September 27, 2016

## ADDENDUM NO. 1

Youngstown State University  
Project No. 1516-96  
Beeghly Center – New Exercise Room

A1.0

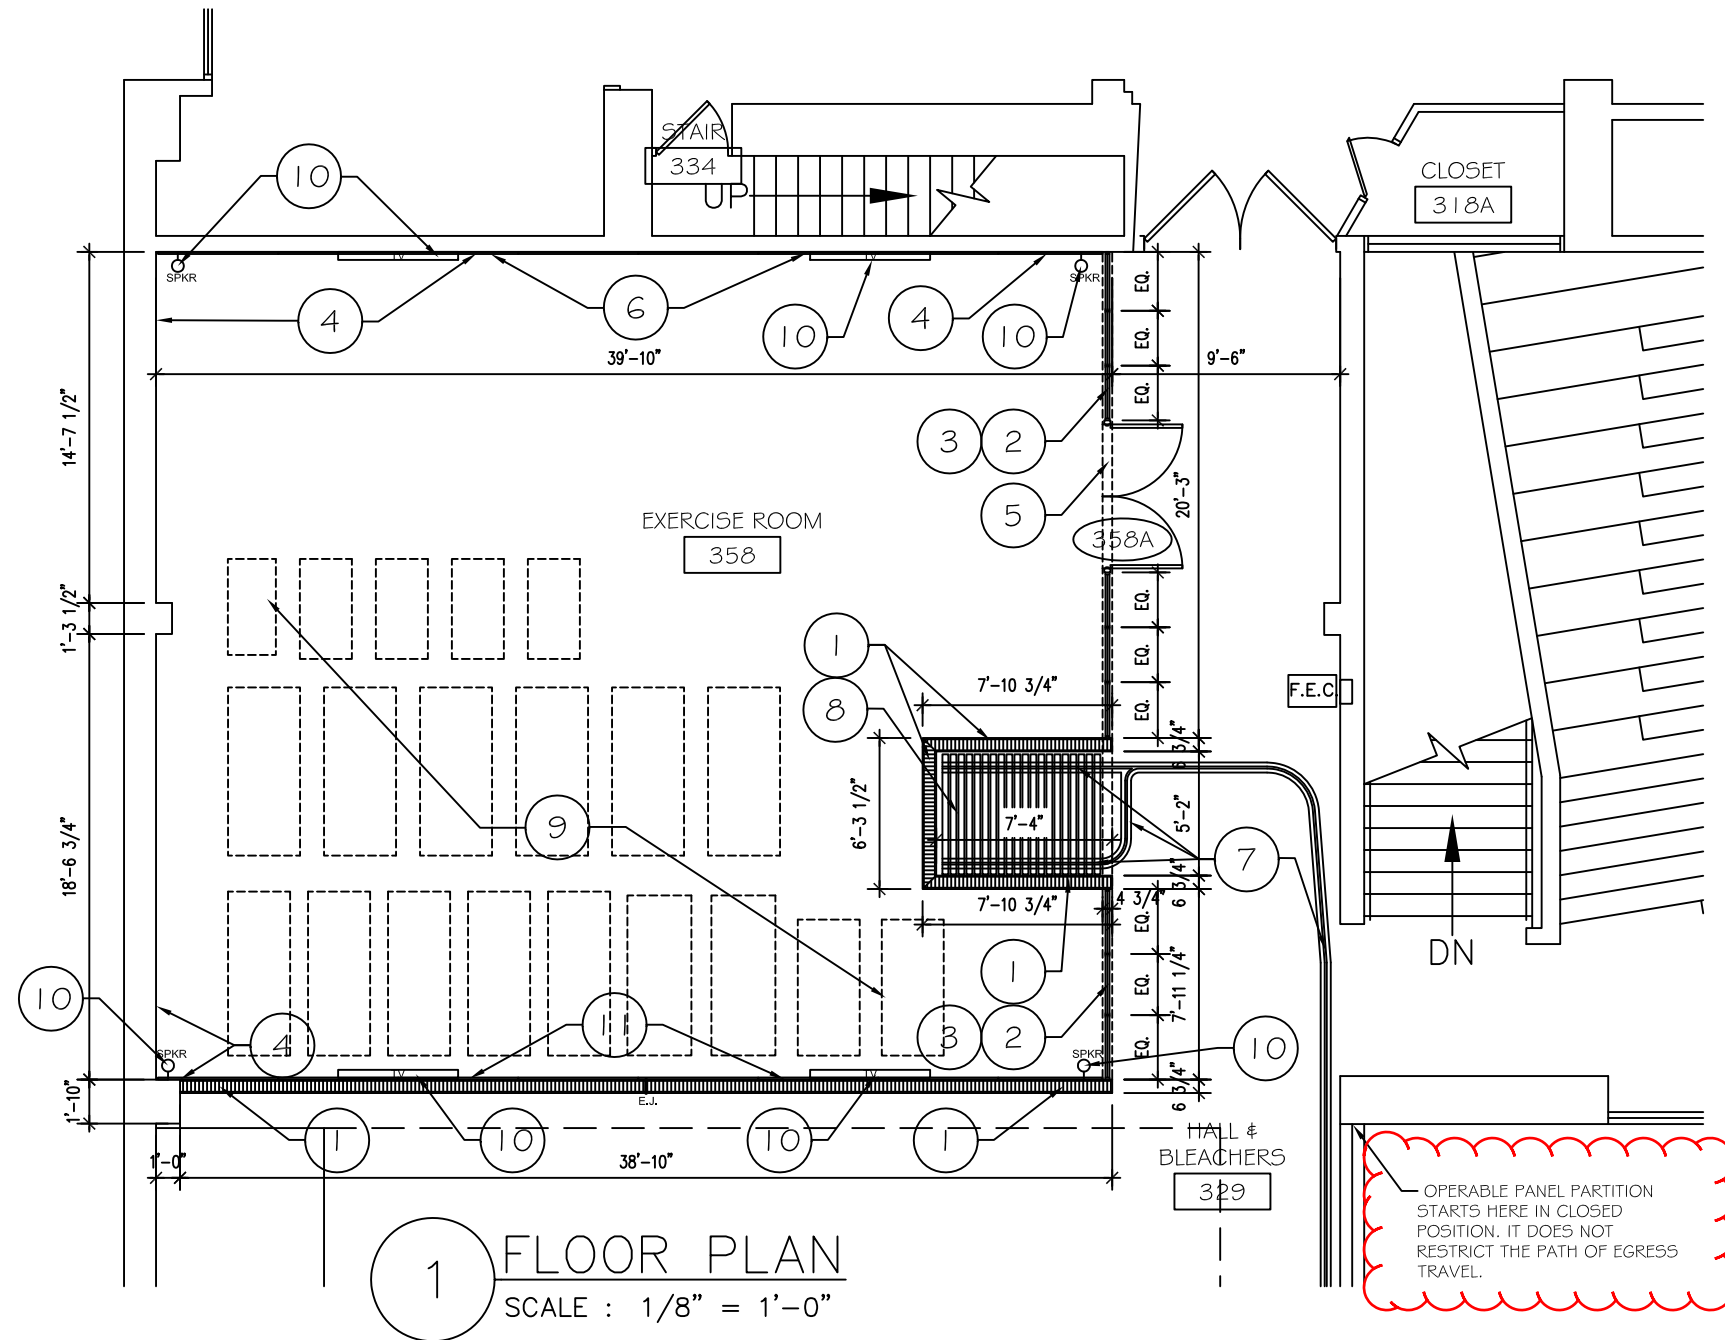
3. A1.0 – Floor Plan: See attached revised Floor Plan for the additional notes regarding the existing panel partition, specified use of Tempered Glass, and revisions to the Mirrors.
4. A9.0 – Schedules & Details: See attached revised drawing with revisions to the Door Hardware Closer, and Room Finish Schedule Note #1.
5. S1.0 – Structural Roof Plan: See attached revised Structural Drawing for the additional note regarding the support for the new RTU.
6. M2.1 – HVAC Plan: See attached revised Mechanical Drawing for additional note to ductwork support.
7. M3.1 – HVAC Schedule: See attached revised Mechanical Drawing for the addition of a Hot Gas Reheat to the RTU.
8. M3.2 – HVAC Specs: See attached revised Mechanical Drawing for additional note to ductwork support.

- INTERIOR TEMPERED GLASS PARTITION FROM FINISH FLOOR TO 8'-0". PROVIDE ANODIZE ALUMINUM FRAME - 2" TOP & 4" BOTTOM UNITS, BUTT JOINT VERTICAL GLAZING CONNECTIONS. PROVIDE INTEGRAL DOUBLE DOOR SYSTEM. INCLUDE TREATED WOOD BASE UNDER GLAZING SYSTEM TO ALIGN WITH TOP OF FINISH FLOOR.

- EXISTING CMU BLOCK WALL TO REMAIN & PAINTED PER THE ROOM FINISH SCHEDULE.
- PROVIDE TRANSITION STRIP AT DOORWAY. ALUMINUM FINISH.
- INSTALL 7'-6" HIGH MIRRORS ALONG THE FULL LENGTH OF THE WALL. INSTALL AT 6" AT THE BOTTOM.

- NEW OPERABLE PANEL TRACK AND SUPPORT STEEL ABOVE. COORDINATE WITH STRUCTURAL DRAWINGS.
- NEW AREA FOR EXISTING OPERABLE PANEL PARTITIONS TO NEST. COORDINATE FINAL WALL AND GLASS DIMENSIONS WITH STRUCTURAL & MANUFACTURER'S REQUIREMENTS.

- INSTALL 6'-0" HIGH MIRRORS ALONG THE FULL LENGTH OF THE WALLS. INSTALL AT 24" AT THE BOTTOM.

ELECTRICAL RISER DIAGRAM

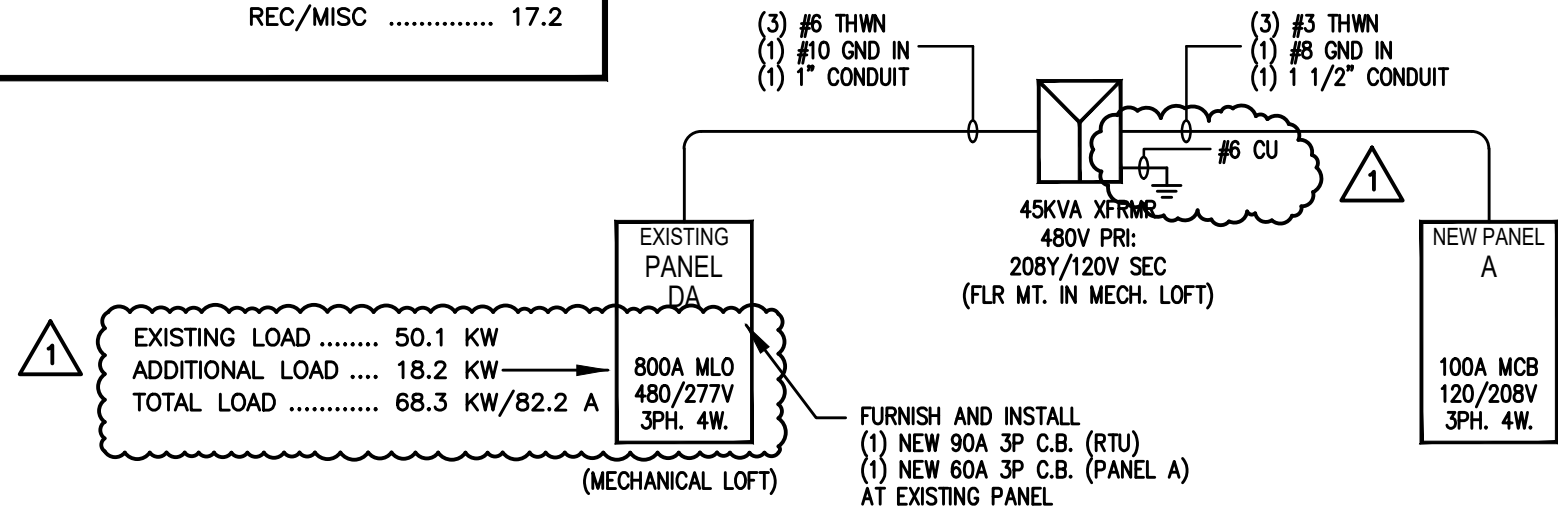
9. E1.0 – Electrical Plan: See attached revised Electrical Drawing for the addition of smoke detector, additional outlet to the new south wall, and revision to AV area.
10. E3.0 – Electrical Riser Diagram: See attached revised Electrical Drawing for the addition and clarification to the Riser Diagram.
11. E4.0 – Electrical Device Legend: See attached revised Legend to include Smoke Detector, and revisions to Media connections.

# HVAC CURB

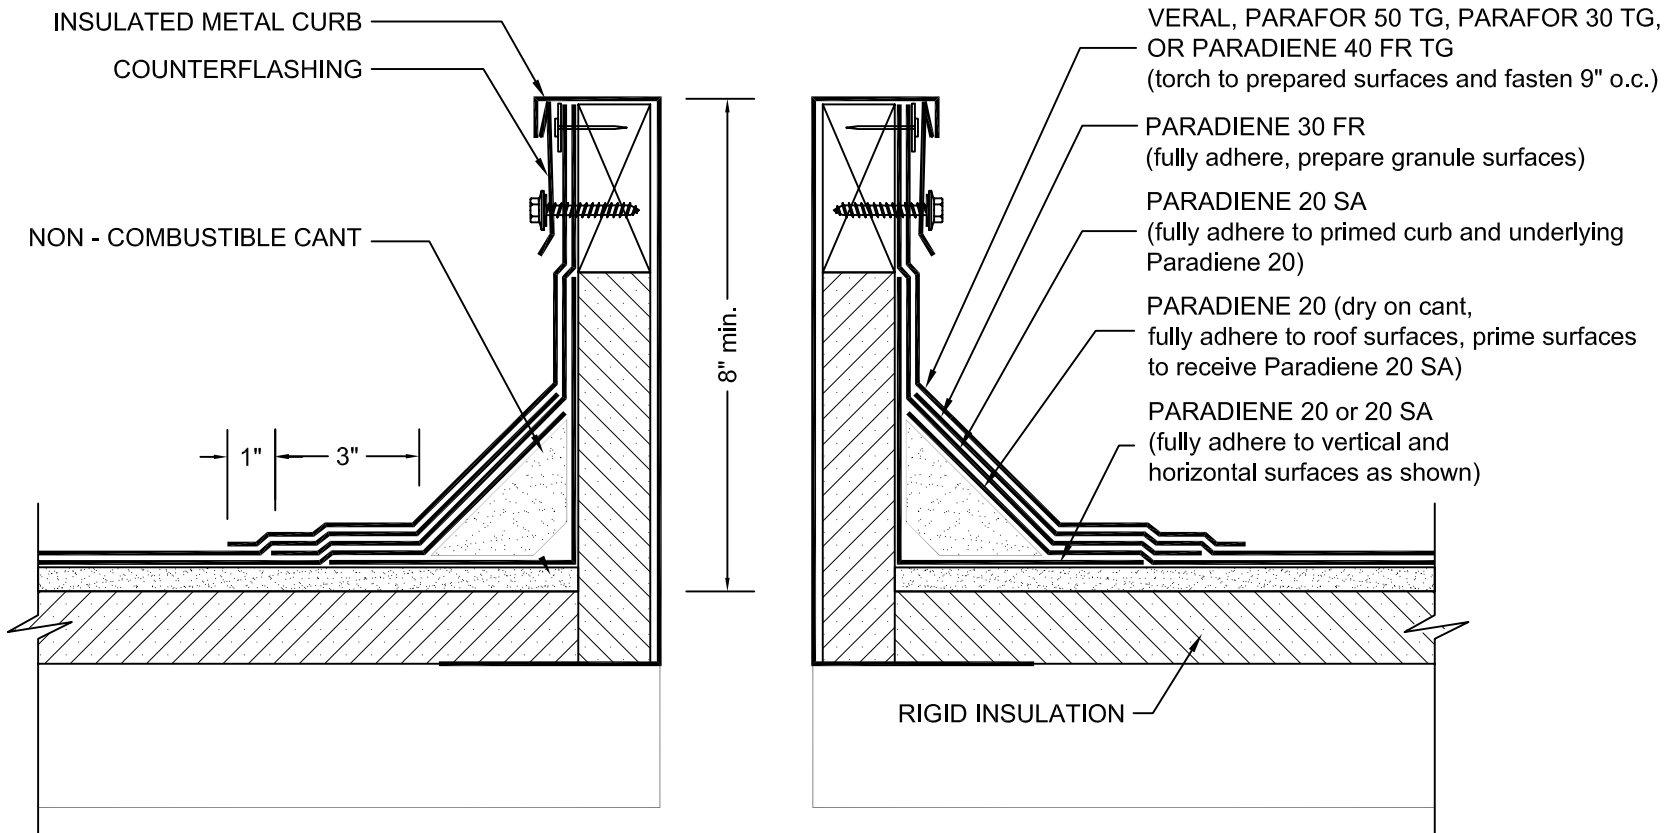
12. See attached Siplast Roof curb detail for roofing coordination with the new RTU.
13. See attached Statement of Special Inspections. YSU will hire an independent Inspection Company to inspect the Steel fabrication and construction as identified on the form.
